**Item 3.****Section 8.2 Review of Determination - 21 O'Connor Street, Chippendale - RD/2018/1360/A**

File No.: RD/2018/1360/A

The original application sought consent for alterations and additions to the existing mixed-use warehouse building to include a new commercial studio, courtyard and garage on the ground floor; internal reconfiguration of the first floor; extension of the second floor onto the existing outdoor terrace; and addition of a roof terrace above.

Figure 8: Proposed ground floor plan

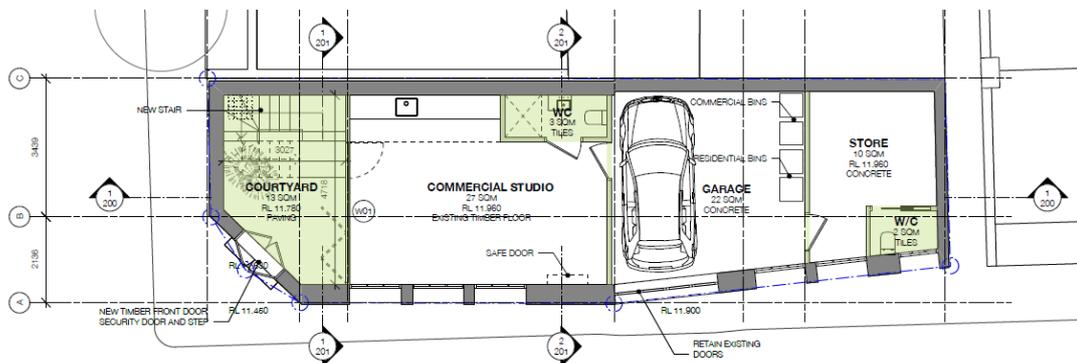
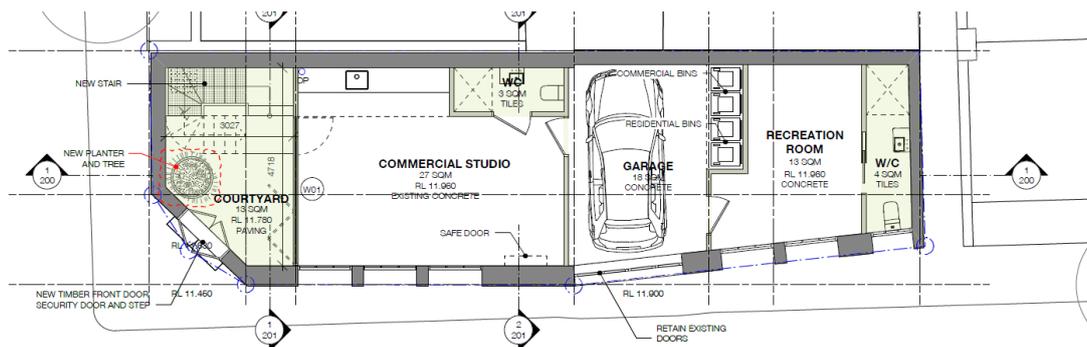
- (a) Internal alterations at ground floor level including a reduction in the size of the garage and use of the store room as a recreation room.
  - (b) Addition of a balcony adjacent to the external stairs at first floor level.

Figure 12: Proposed second floor plan

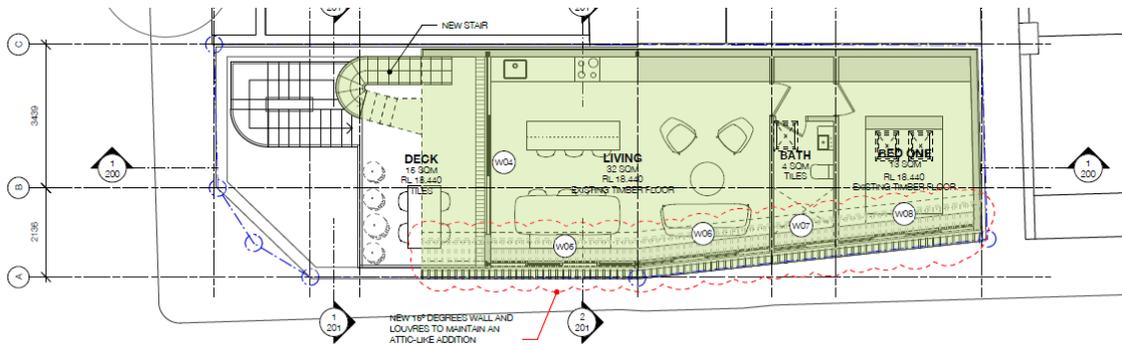
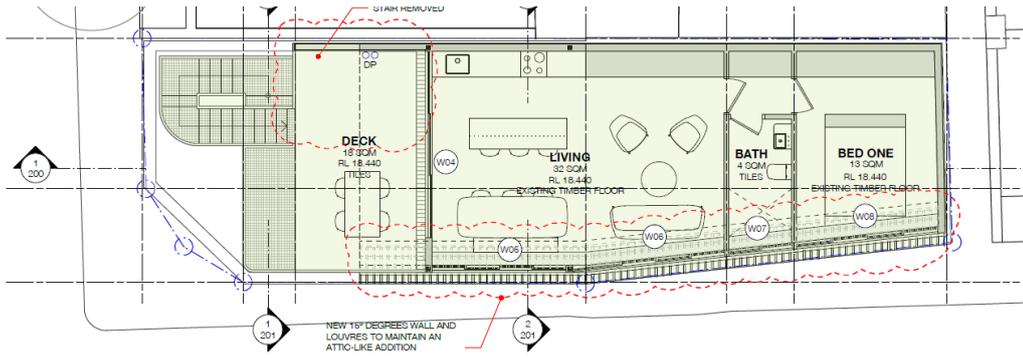
- (c) Deletion of the roof terrace and associated access stairs.
  - (d) Provision of additional solar panels on the roof (13 in total).
  - (e) Amendments to the roof addition including alterations to glazing, the addition of louvres and amendments to the materials.

**Figure 23:** Proposed west elevation with 9m height control shown in red and the height of the existing building shown dashed in blue.

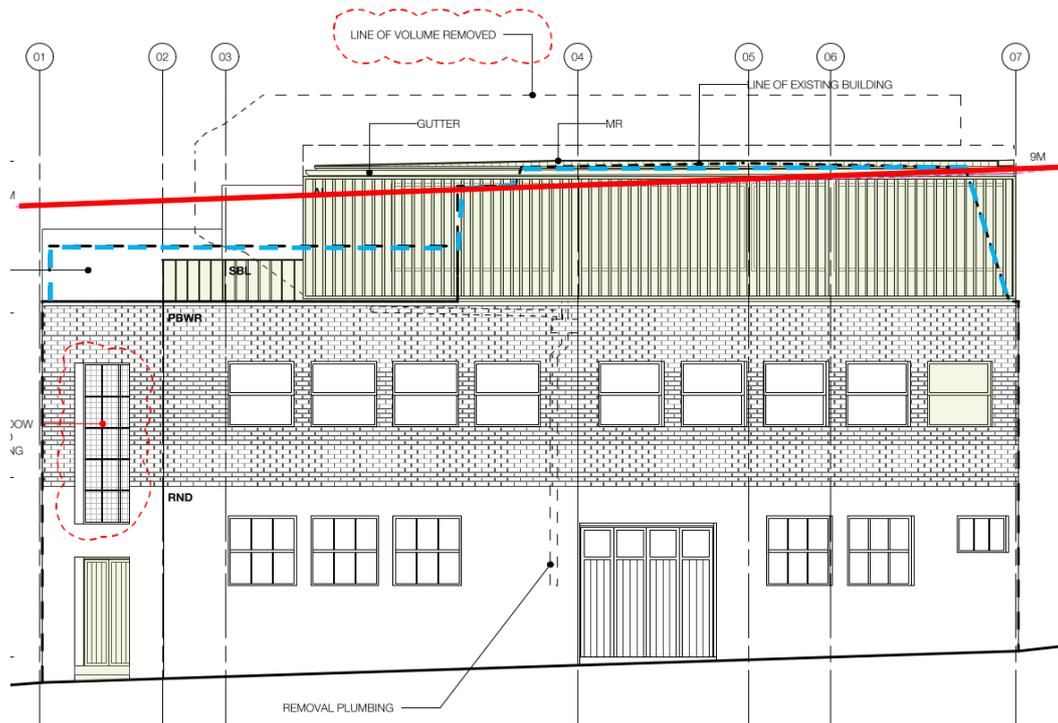
44. The site is subject to a maximum Height of Buildings control of 9m. The existing building has a height of 9.41m (RL21.18) and the proposed development has a maximum height of 9.56m (RL21.30).
45. The variation to the height control results in an exceedance of the development standard by 0.56m which equates to a 6.22% variation.

46. The red line in Figure 23 shows the 9m height control in context with the proposed development.

**Figure 24:** Existing and proposed GFA diagrams submitted by the applicant. The GFA is shown in red.

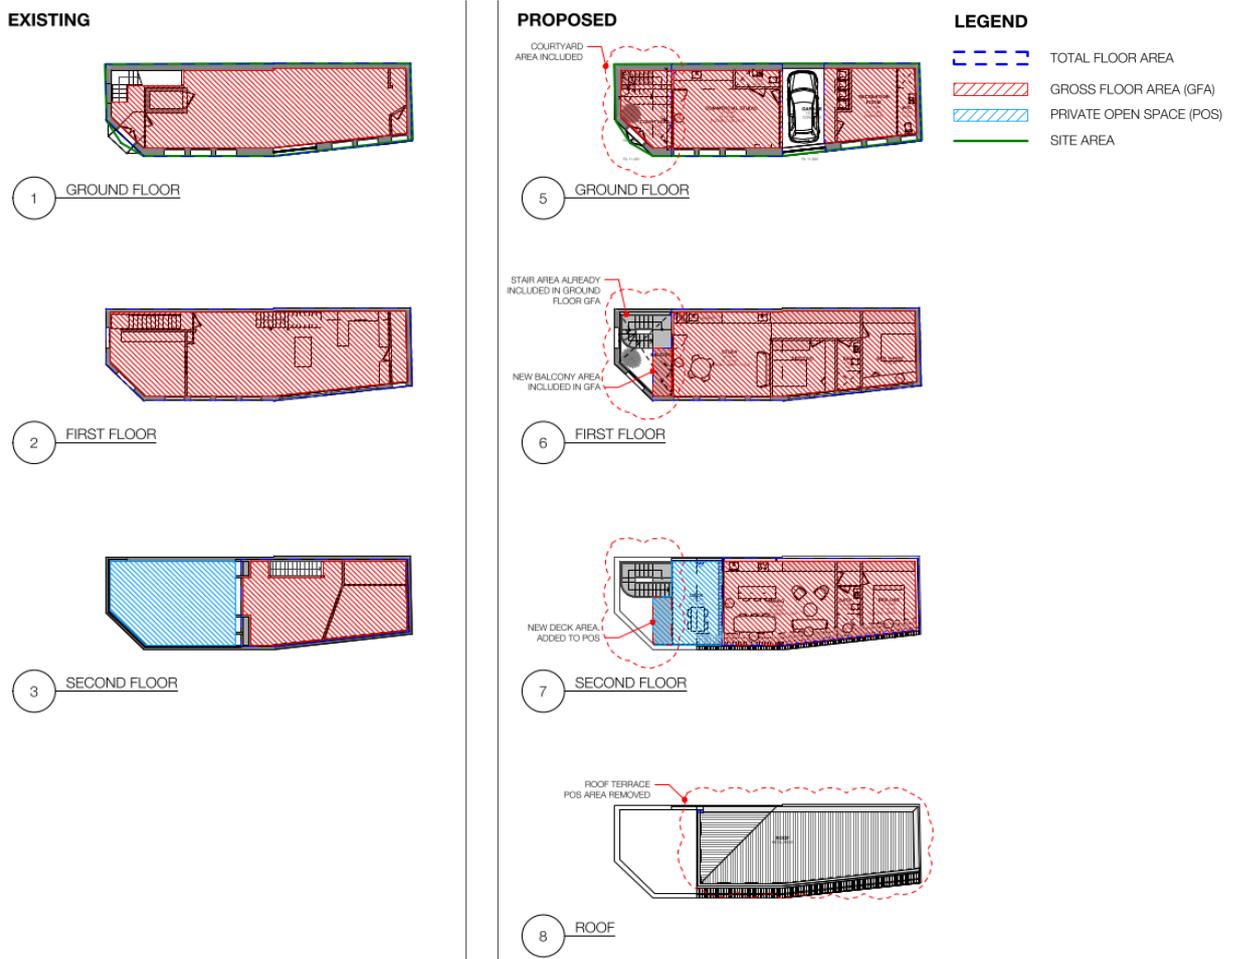
59. The site is subject to a maximum Floor Space Ratio (FSR) of 1.5:1. The proposed development has an FSR of 1.89:1.
60. The existing building has an FSR of 2.11:1. The proposal results in a net decrease of 14.59sqm of floor space due to the installation of a void at first and second floor levels and the provision of a car parking space at the ground floor level. Despite the reduction in floor space, the development still represents an exceedance of 0.39:1 which equates to a 26.3% variation to the FSR development standard.
61. Figure 24 shows the Gross Floor Area plans submitted by the applicant.
